# Access Compliance Report

## Public Rights-of-Way

| Intersection ID: 3829 | Main Street: BROWNE'S_FERRY_RD | Cross Street: KINSMORE_LN | Location:              | N                     |
| ADA ID: 449B0EC010E9  | Ramp Type: Directional1        | Initial Pass/Fail: Fail   | Overall Compliance: No | Severity Score: 13.75 |

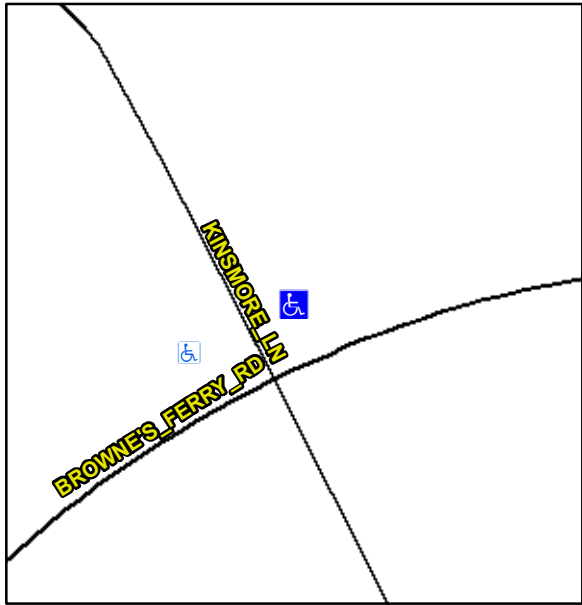
| Codes/Mitigation Info/Possible Solution   |                               |            | Field Measurements/Component Compliance |                       |       |            |                             |      |
|---|-------------------------------|------------|---|-----------------------|-------|------------|-----------------------------|------|
|   |                               |            | No                                      | Ramp Slope (%)        | 10.6  | N/A        | Grade Break XSlope (%)      | 0.0  |
|   |                               |            | No                                      | Ramp XSlope (%)       | 3.1   |            |                             |      |
|   | R304.2.2, R304.5.3            |            | N/A                                     | Shared Landing?       | N/A   | N/A        | DWS Offset RT (in)          | N/A  |

| Codes/Mitigation Info/Possible Solution   |                               |            | Field Measurements/Component Compliance |                       |       |            |                             |      |
|---|-------------------------------|------------|---|-----------------------|-------|------------|-----------------------------|------|
|   | Remove & Replace Entire Ramp. |            | N/A                                     | Ramp Length (in)      | 73.0  | N/A        | Grade Break?                | N/A  |
